24 January 2020
Our Ref: 9809A.13PS_s4.55(1A)

**RE: SECTION 4.55(1A) APPLICATION TO MODIFY SSD 8365 (MOD 1)
PENSHURST PUBLIC SCHOOL
510 FOREST ROAD, PENSHURST**

The section 4.55(1A) application (Mod 1) seeks to modify Condition A2 relating to the approved plans in order to adjust two (2) stairwells, incorporate a new stairwell to reduce egress distances and implement some minor layout changes, as well as include a fire sprinkler system.

Figure 2 Extract of Site Masterplan indicating location of proposed modifications

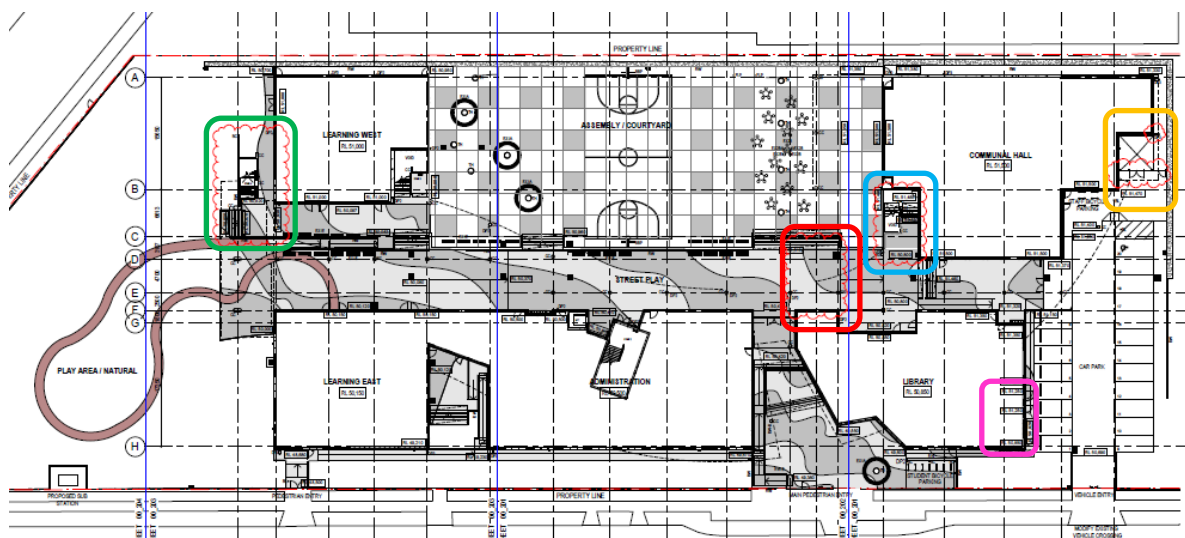
- Reorientate Stair 1 by 180 degrees, add extra flight to street play area, and add new column 300 x 400mm under landing (see **Blue** mark up in **Figure 2**);

- Reduce area of sports store (see **Orange** mark up in **Figure 2**);
- Add new Stair 4 at the southern end of the school building (see **Green** mark up in **Figure 2**);

- Minor adjustment to ramp for stormwater coordination to remove level change adjacent to stairs and allow for new pit (see **Red** mark up in **Figure 2**);

- Installation of sprinkler system to service the building, including installation of a sprinkler pump adjacent to the existing Fire Hydrant pump room at the north east of the school building (see **Pink** mark up in **Figure 2**);
